City of Detroit
Inter-Departmental Communication

RE: Petition #817
Request for Conversion To Easement The Alley In The Area Bound By Fielding,
Glendale, Stout, And Fullerton

CONVERSION TO EASEMENT
 THE PUBLIC ALLEY, 16 FT. WD.
 IN THE BLOCK BOUND BY
 FIELDING AVE., GLENDALE AVE.,
 STOUT AVE. AND FULLERTON AVE.

CITY OF DETROIT CITY ENGINEERING DIVISION SURVEY BUREAU	
JOB NO.	01-01
DRWG. NO.	X 817

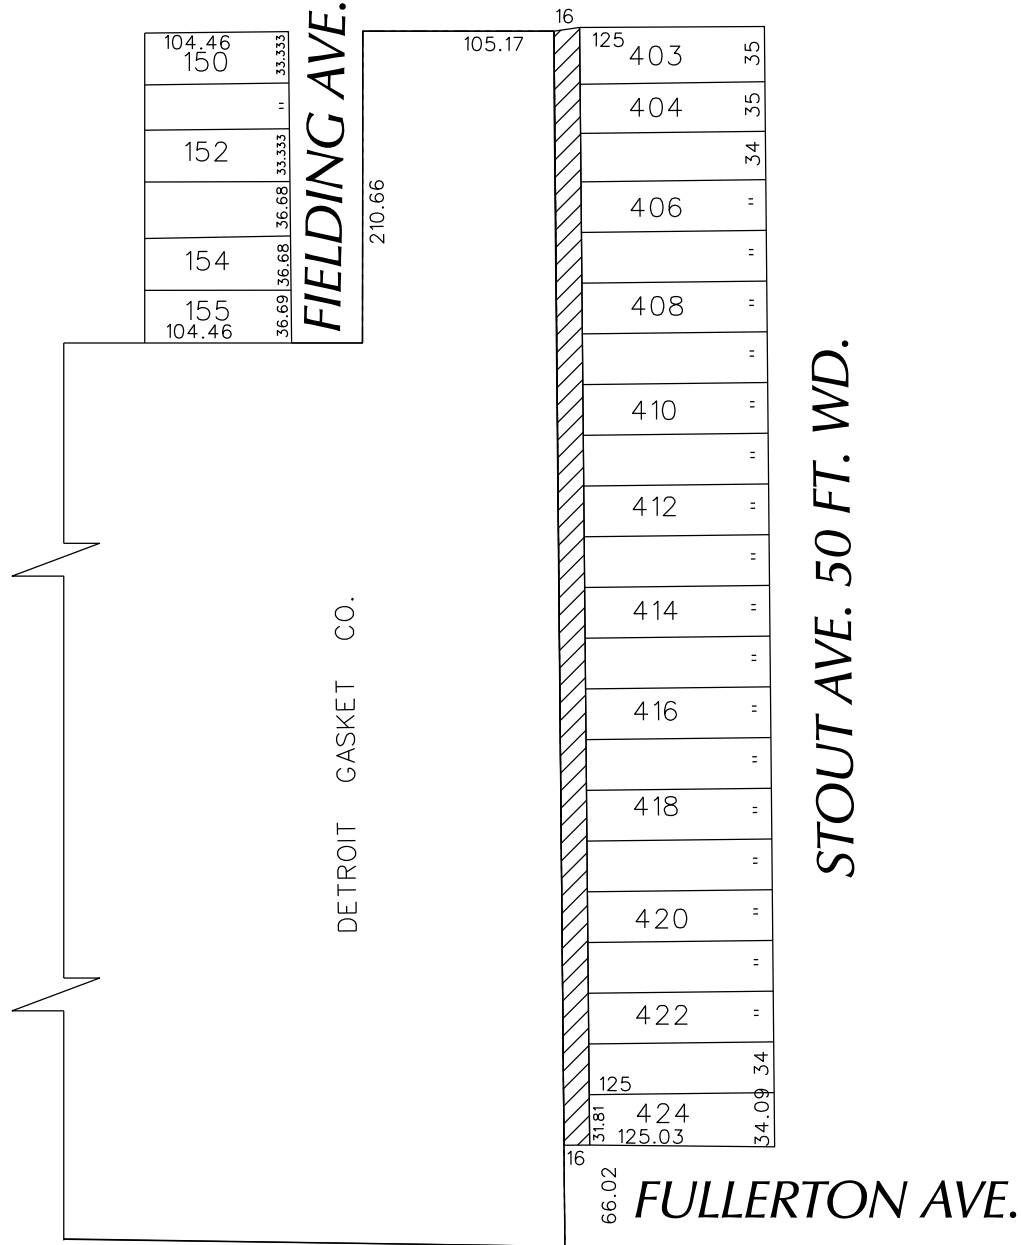
The above petition received by this office has been reviewed. With regard to DWSD's interests, our comments are as follows, our records indicate that there is a sewer in the alley. DWSD has no objections to the conversion to easement provided that the attached provisions for conversion to easement are followed.

1. An easement, the full width of the existing right of way, is reserved for the Detroit Water and Sewerage Department for the purpose of installing, maintaining, repairing, removing, or replacing any sewers, water mains, fire hydrants and appurtenances, with the right of ingress and egress at any time to, and over said easement for the purpose above set forth.

Free and easy access to the sewers, water mains, fire hydrants and manholes and structures within the easement is required for Detroit Water and Sewerage Department equipment, including the use of backhoes, bull dozers, cranes or pipe trucks, and other heavy construction equipment, as necessary for the alteration or repair of the sewer or water main facilities.

2. Said owners of the adjoining property, for themselves, their heirs and assigns, agree that no building or structure of any nature whatsoever, including fences, porches, patios, balconies, etc., shall be built upon or over said easement, or that no grade changes or storage of materials shall be made within said easement without prior written approval and agreement with the Detroit Water and Sewerage Department.
